NEW BRITAIN – HARTFORD BUSWAY

PERMITTING SUBMISSION

FLATBUSH AVENUE STATION

**8. Appendix E: CTDOT Preliminary Design  
Comment Responses**

TOWN:  
**WEST HARTFORD**  
DRAWING TITLE:  
**FLATBUSH AVE. STATION  
DRAINAGE PLAN**

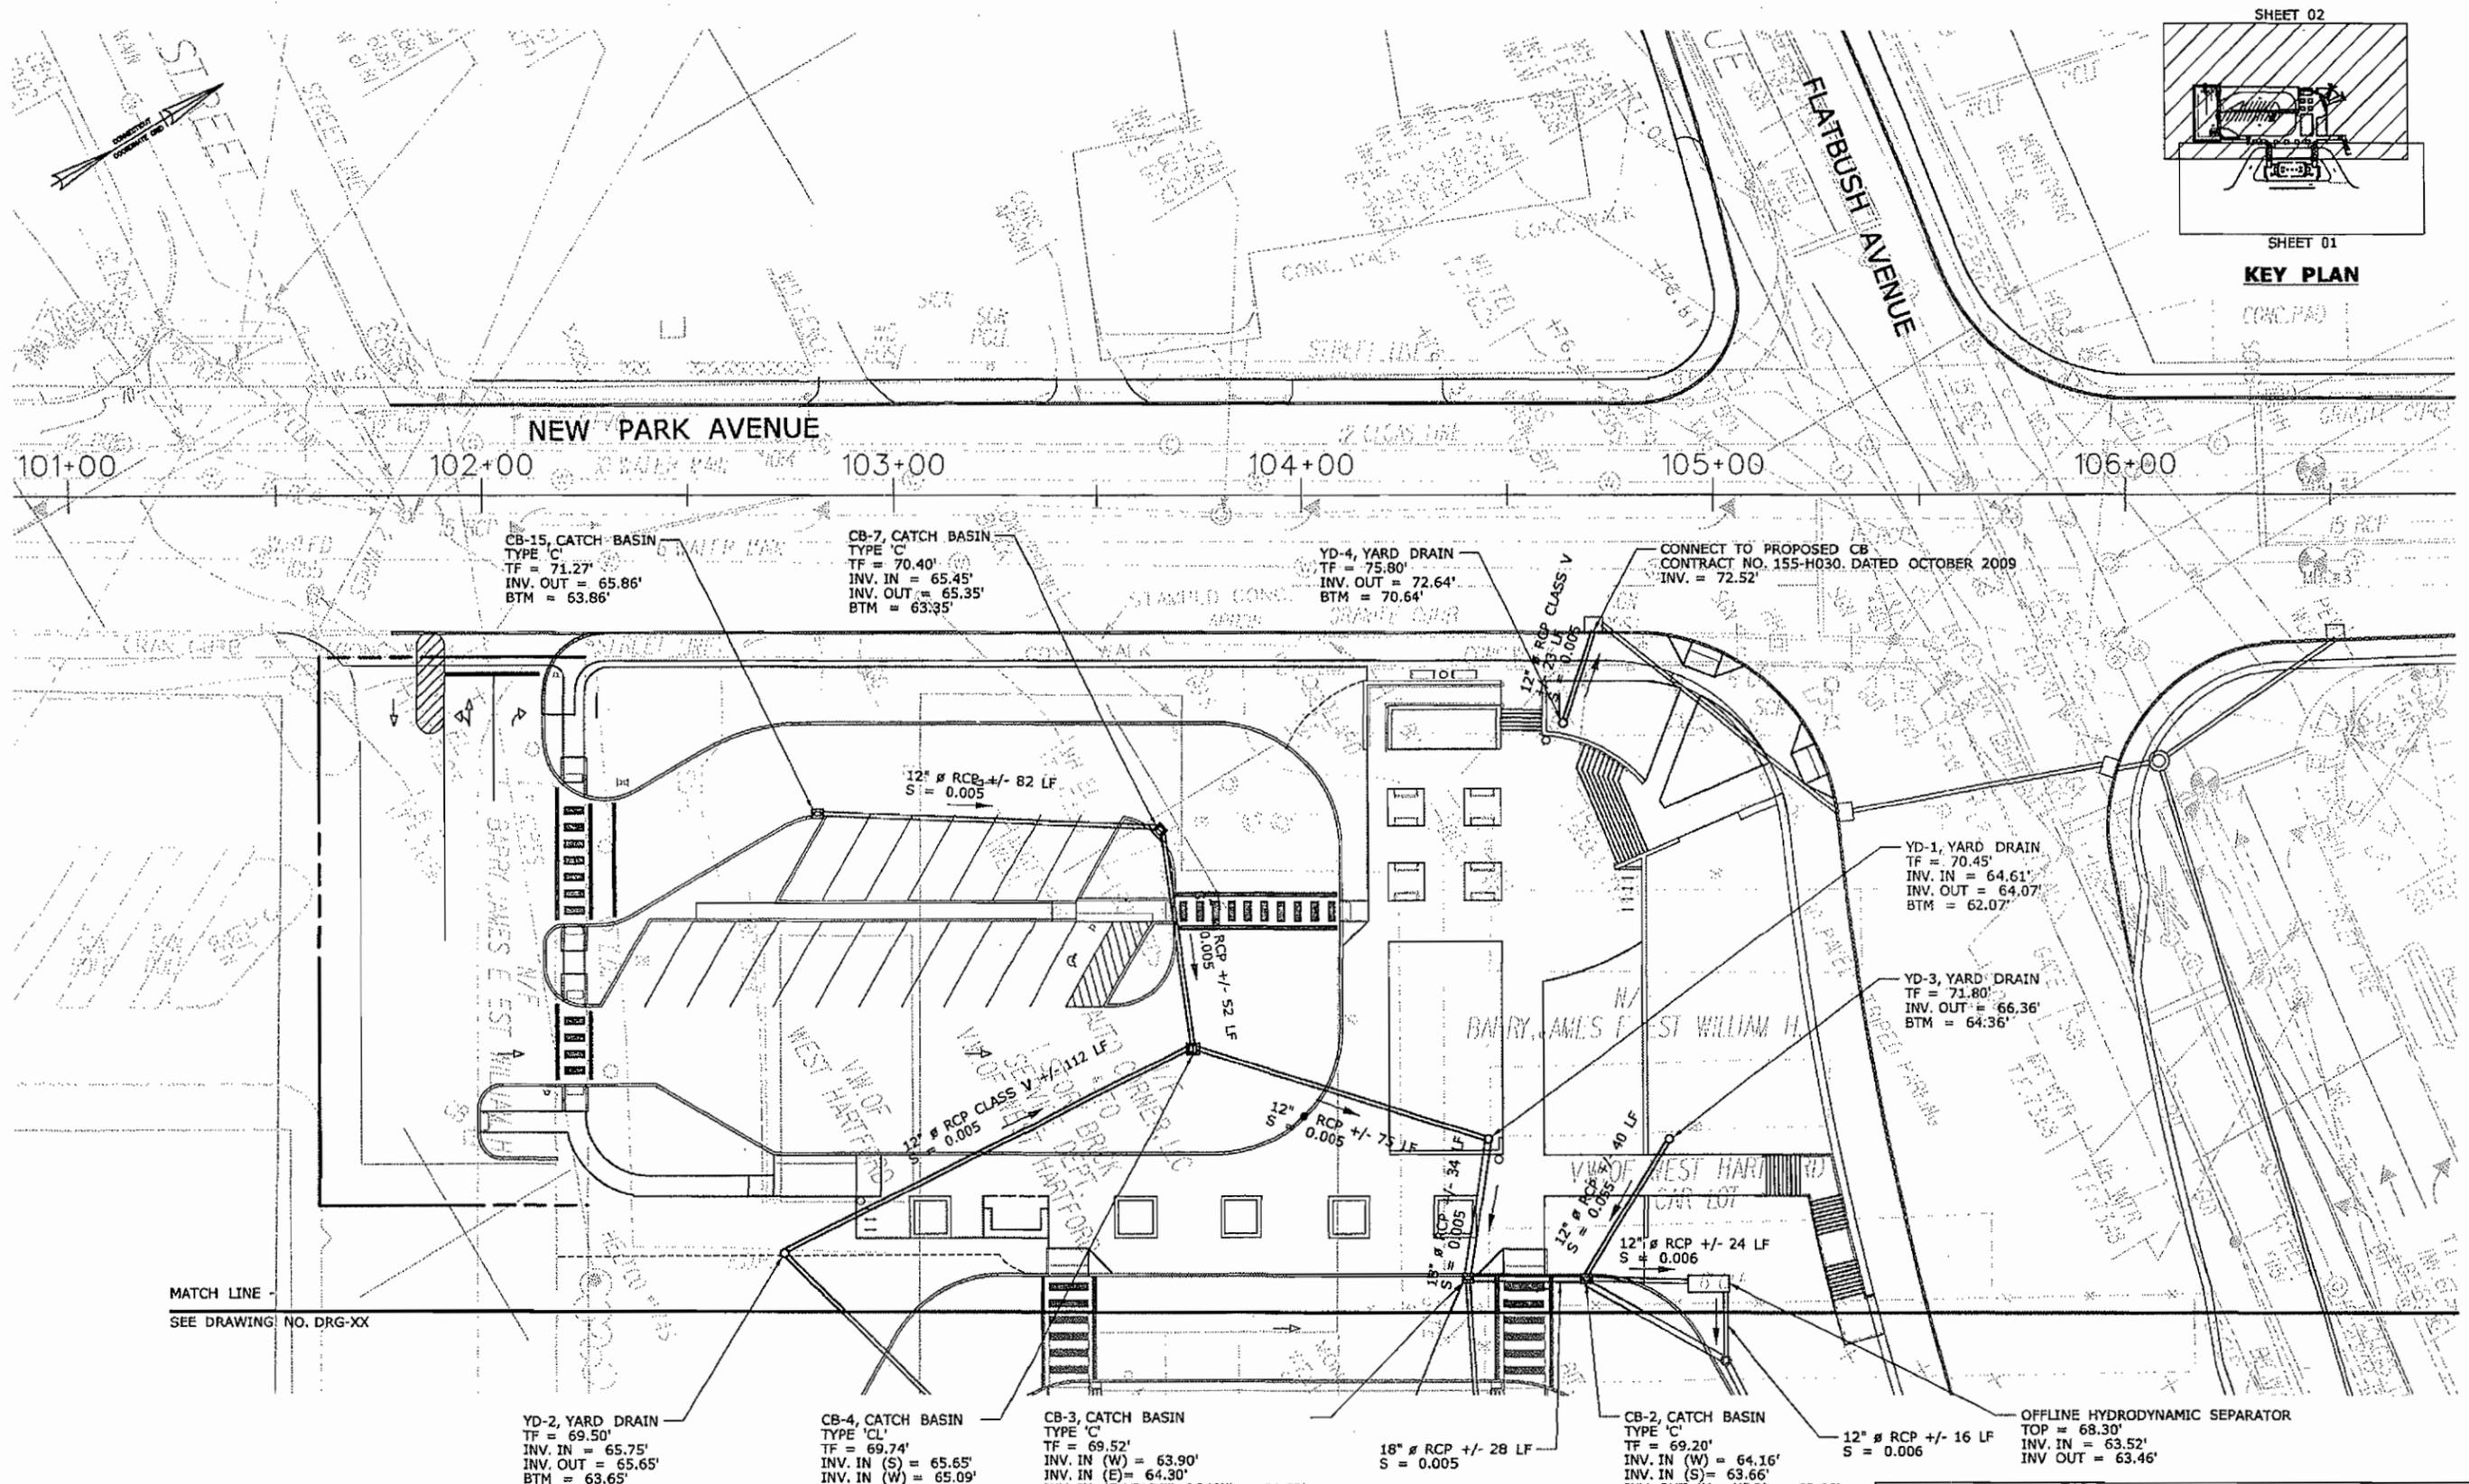
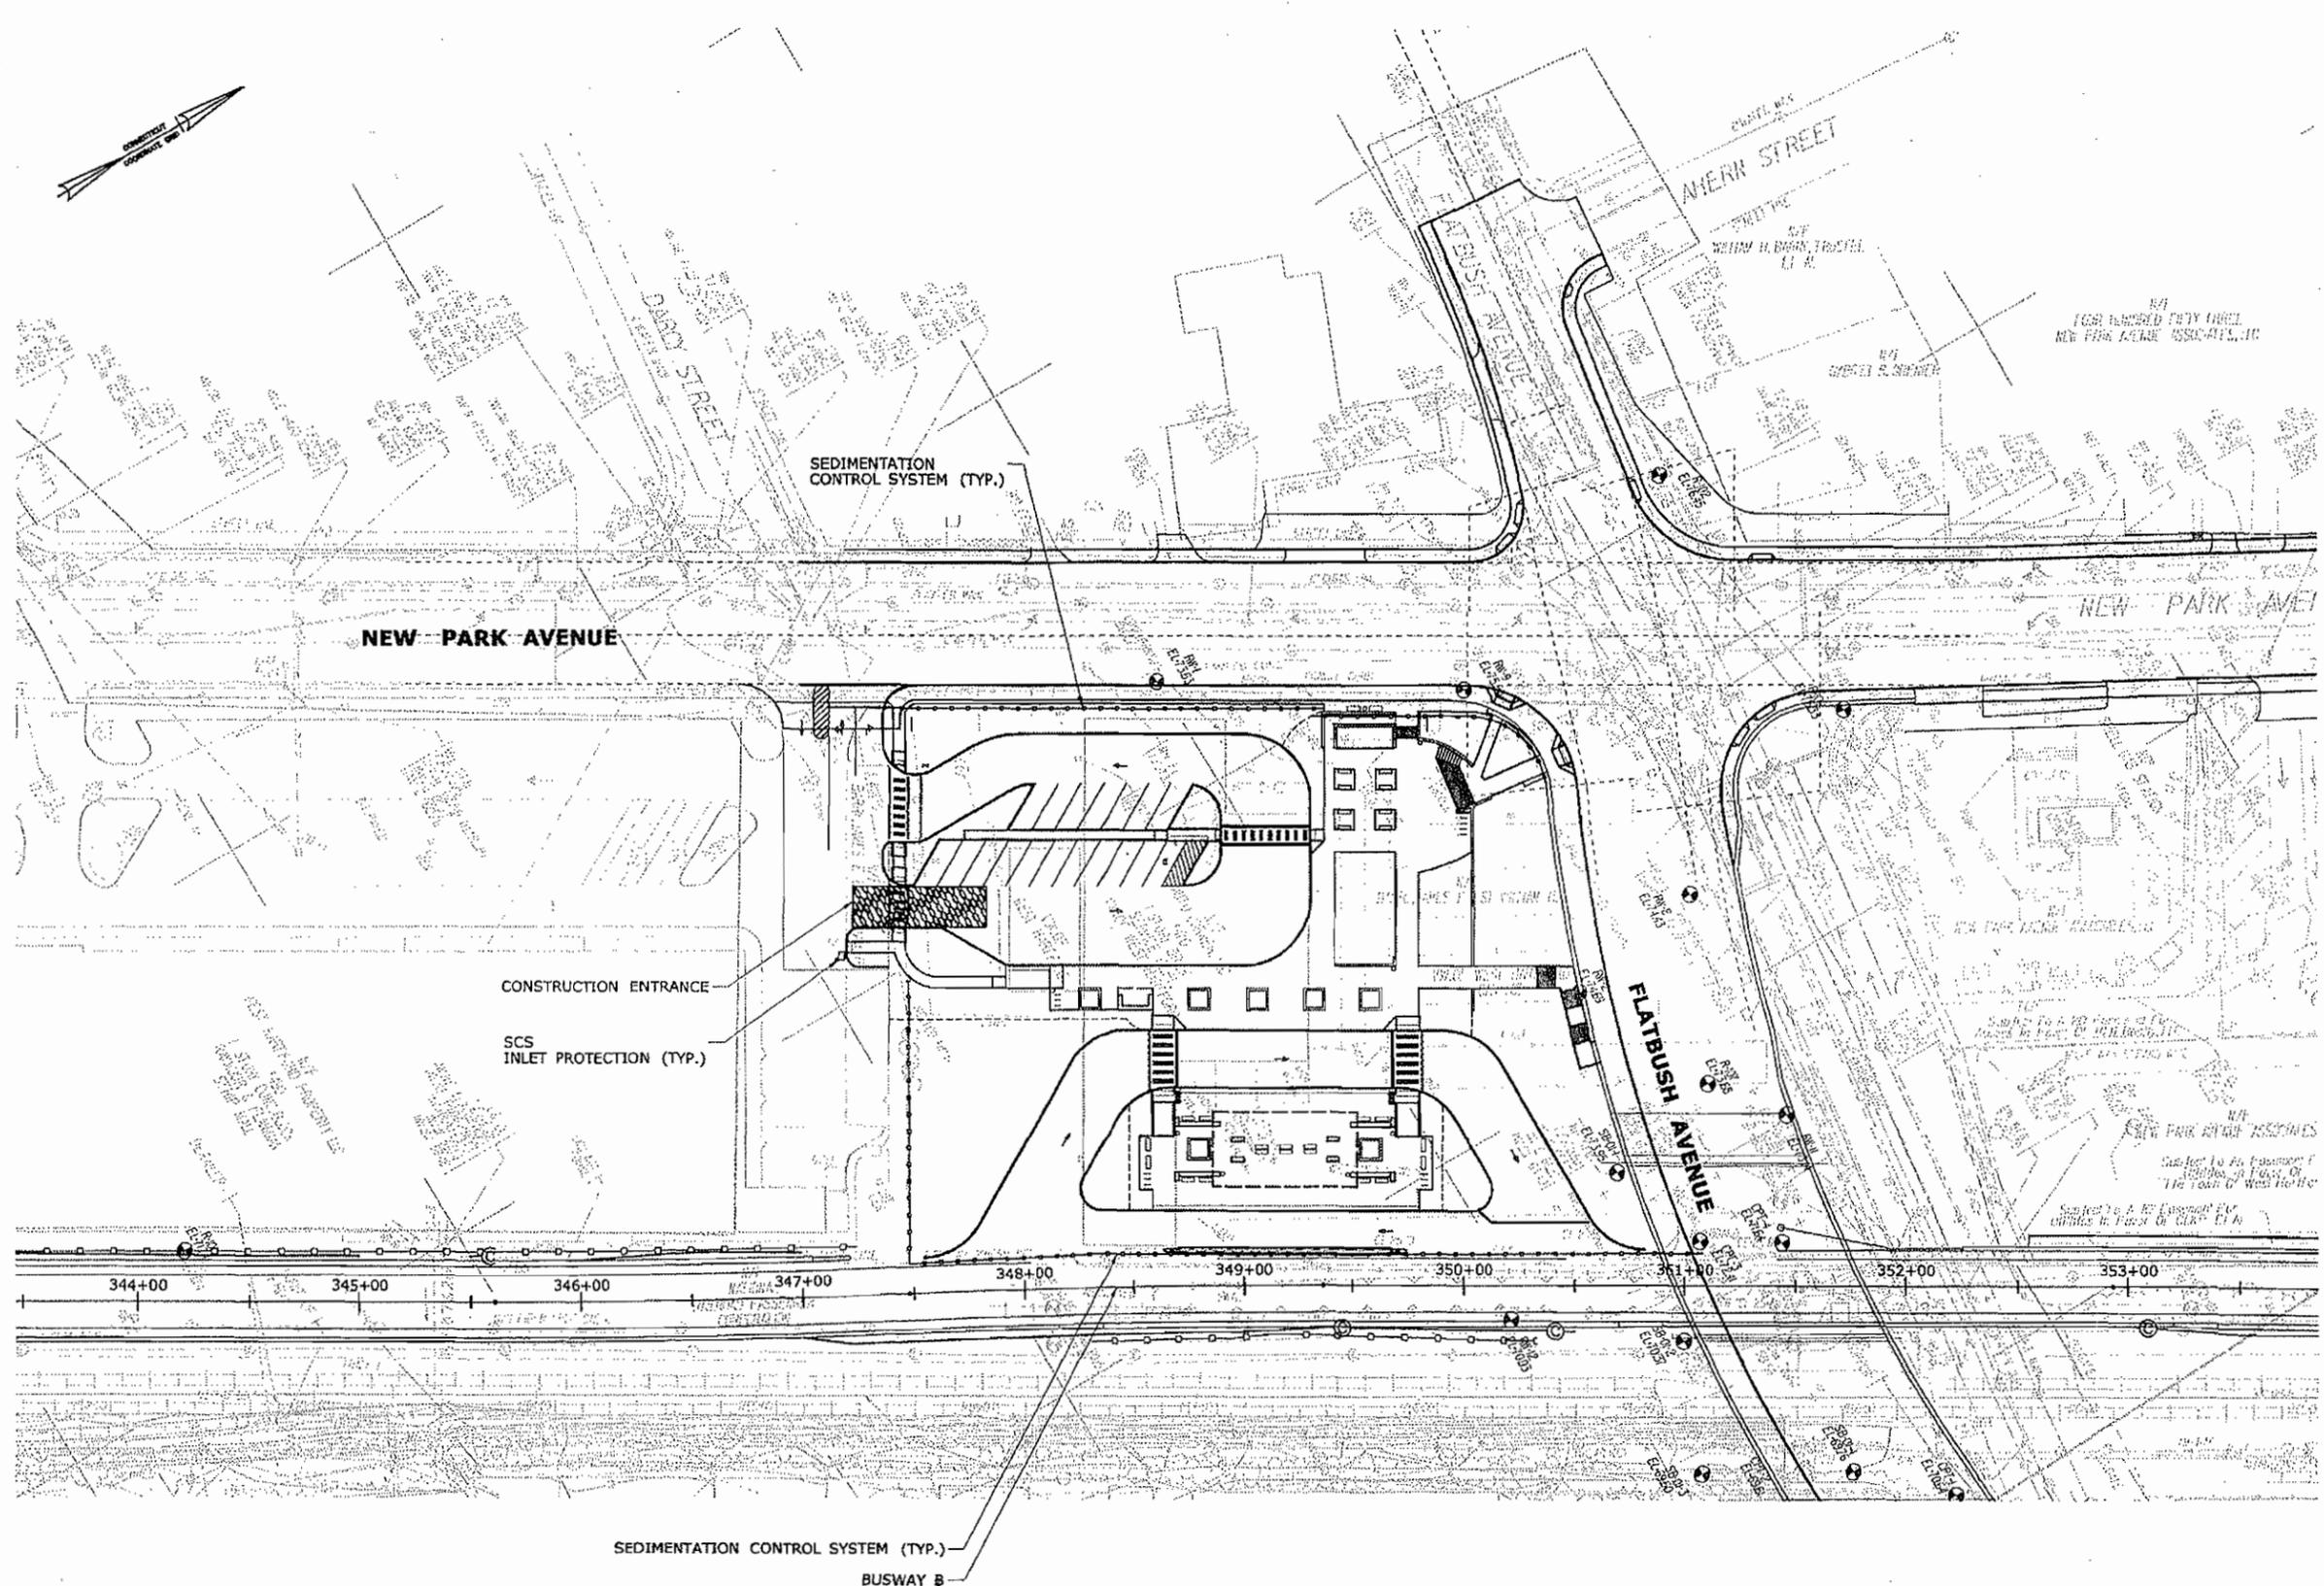
- 3 | The proposed contour line that is near CB #5 is labeled as elev. 71.6, which is one foot higher than the surrounding contour elevations, labeled as elev. 70.6. Review and revise accordingly.

- 4 | Include the busway mainline stations on the Drainage Plan for reference.

- b. If it is verified the hydrodynamic separator referenced in comment No. 2 above is needed, consideration should be given to relocating it to the grass area just north of CB #1 in order to ensure all facility flow is treated.

- Provide flow arrows for all drainage.

- **Drainage plan sheets do not appear to have flow arrows for proposed pipes...please include**

**S E A Response:** *The contour label has been corrected.*

**S E A Response:** *Stationing has been added.*

**S E A Response:** *The HDS is proposed just upstream of Catch Basin #1 to allow treatment of all site flows. Locating it downstream of Catch Basin #1 would require its installation within the busway lanes and hampering maintenance activities.*

*S E A Response: Flow arrows have been added to the drainage plan sheet.*

**S E A Response:** *Flow arrows have been added to the drainage sheets.*
